Report: TAB REPORT
Function: Test, Adjust, & Balance
Date: 10/25/2023

PROJECT

**09-04-23 CHICK-FIL-A #05049 -
CHRISTIANSBURG, VA (CHRISTIANSBURG
FSU) NEW STORE**

EF2
09/06/2023

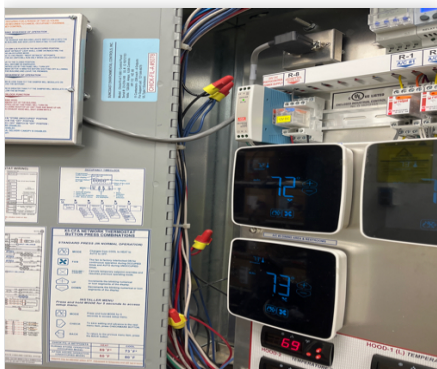
Issue Name : Non-Critical - EF2 / Cleanout Door
Description : EF2 grease duct installed slightly different then shown on prints causing one grease cleanout door to be located in a different location then shown on prints. Page: M-250 Detail: 1
Created By : National TAB **Assigned To :** National TAB - Dale Wheeler
Status : Open
Originated Date : 09/06/2023 - Dale Wheeler - National TAB
